SUBJECT: Response to Request for Additional Information Regarding the License
Amendment Request to Implement 10 CFR 50.61a
(TAC No. MF4528)

Palisades Nuclear Plant
Docket No. 50-255
License No. DPR-20

Response to Request for Additional Information Regarding the License Amendment Request to Implement 10 CFR 50.61a

Figure 4-1 Identification and Location of Beltline Region Materials for the Palisades Reactor Vessel⁽³⁾

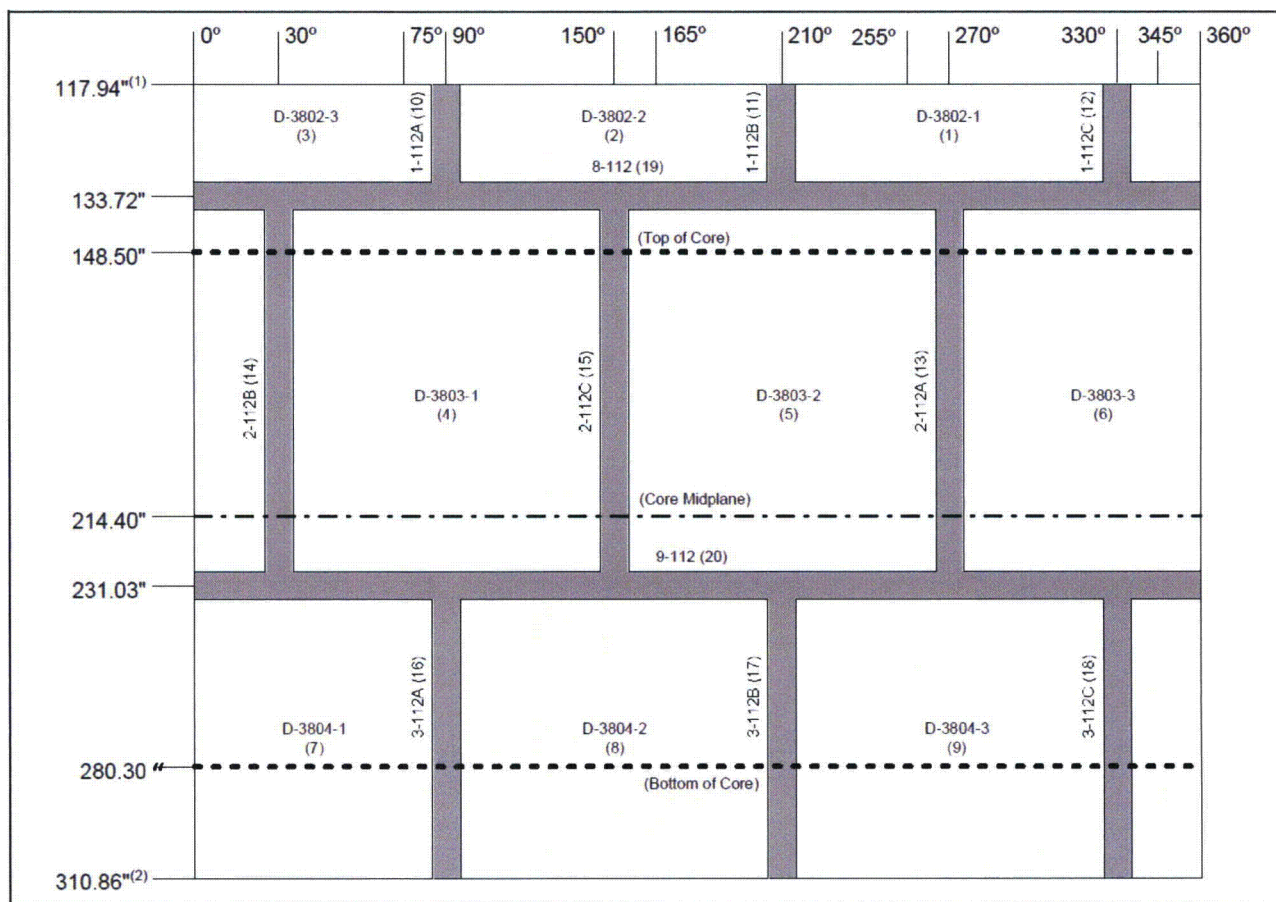
Table 5-1, "Maximum Neutron Fluence on the RV Clad-to-Base Metal Interface for Palisades at 42.1 EFPY" of the LAR, lists that the values for the intermediate and lower longitudinal (axial) welds in the vessel are the same, 2.161×10^{19} neutron/cm² ($E > 1.0$ MeV), which is 63% of the peak values for the adjacent intermediate and lower shell plates. The methodology for determining the maximum fluence at the axial welds relative to the maximum fluence in the adjacent plates is not discussed in the LAR.

Provide a discussion of how the maximum fluence for each region and component in Table 5-1 was determined from the detailed fluence information contained in References 8 and 13 listed in Section 10 of the LAR enclosure. For clarity, illustrate the axial position of the active fuel and the azimuthal position of the peak fluence values for the adjacent intermediate and lower shell plates on Figure 4-1, "Identification and Location of Beltline Region Materials for the Palisades Reactor Vessel."

The spatial distribution of the neutron fluence for the Palisades reactor vessel was determined on a cycle by cycle basis using the synthesis methodology described in Reference 8 of the LAR enclosure. This analysis provided a fine spatial grid of fluence values over the inner surface of the reactor vessel. A scan of these fine grid fluence distributions coupled with the knowledge of the locations (axial and azimuthal extent) of individual reactor vessel materials allowed the determination of the maximum for each weld and plate in the beltline region. The locations of the individual materials are illustrated in Figure 4-1 of the LAR enclosure (shown below).

Axial locations of active fuel added to Figure 4-1:

Core Top	148.50 inches
Core Midplane	214.40 inches
Core Bottom	280.30 inches

Azimuthal locations of peak fluence added to Figure 4-1:

Intermediate Shell Plates	75°, 165°, 255°, and 345°
Circumferential Weld	75°, 165°, 255°, and 345°
Lower Shell Plates	75°, 165°, 255°, and 345°
